Responses to Comments

The following Master Responses have been provided in order to address common themes or issues that were raised throughout the comment letters received during Public Review of the Draft EIR for the Trails at Carmel Mountain Ranch Project. These Master Responses are commonly referred to throughout the responses to comments received by agencies, organizations, and individuals.

Figure 1. Locations of five populations of four special-status plant taxa along Chicarita Creek on the project site, as recorded by Hamilton Biological on January 22, 2021. Aerial source: Google Earth Pro.

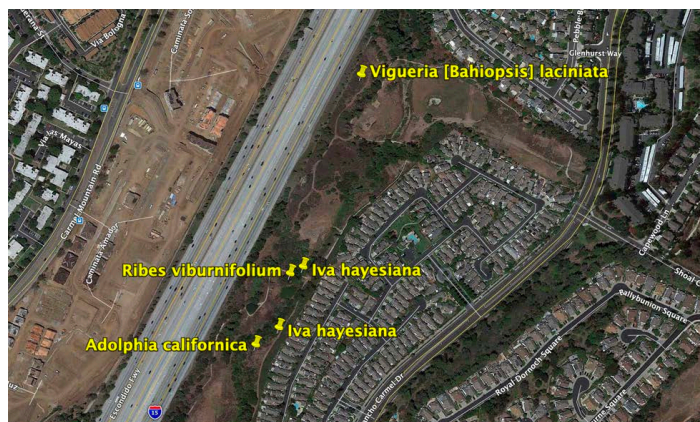
Hamilton Biological detected **five populations of four special-status plant species** – San Diego Marsh Elder (*Iva hayesiana*), San Diego Viguiera (*Viguiera* [*Bahiopsis*] *laciniata*), Catalina Currant (*Ribes viburnifolium*), and California Adolphia (*Adolphia californica*) – none of which the project biologists recorded on the site. Figure 1, on the next page, shows the locations of these plants on the site.

Figure 2. Aerial image, dated March 29, 2020, showing an old golf course pond that appears to satisfy conditions of an “isolated wetland” and “water of the State.” Aerial source: Google Earth Pro.

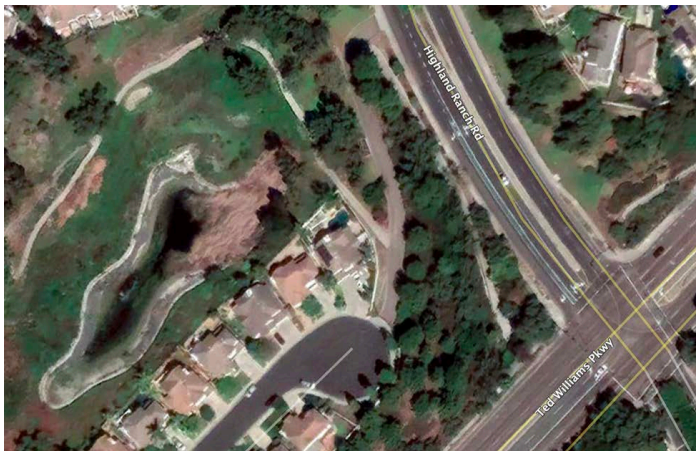
The jurisdictional delineation makes no mention of man-made ponds similar to Features Q and R that are located in areas proposed for grading. Mr. Bailey and I checked the larger of these, which covers approximately 0.7 acre and is located 250 feet north-west of the intersection of Ted Williams Parkway and Highland Ranch Road. We observed that the pond did not have an intact artificial lining, and that its soils consisted of deeply cracked, heavy clay. Roughly the northeastern third of the pond supported a dense stand of native Southern Cattail (*Typha domingensis*), an obligate wetland species, and we heard Baja California Treefrogs vocalizing from the wetland vegetation. The rest of the pond supported a sparse growth of non-native Salt Cedar (*Tamarix ramosissima*), a species that can occur in both wetlands and uplands. See Figure 2, below, and Photos 1 and 2, on the next page.

Figure 3. Locations where Southwestern Pond Turtles have been recorded within 1.5 miles of the project site since 2000 (USGS data). Aerial source: Google Earth Pro.

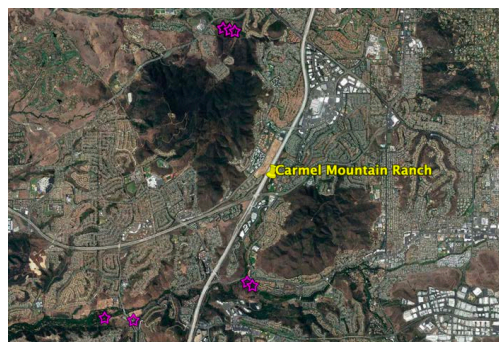
This information is incorrect. The US Geological Survey (USGS) has post-2000 records of Southwestern Pond Turtles from multiple locations within the Poway USGS quadrangle, within 1.5 miles of the project site, at both Los Peñasquitos Canyon to the south and Lusardi Creek to the northwest (Christopher Brown, USGS, email dated February 2, 2021. See Figure 3, below.
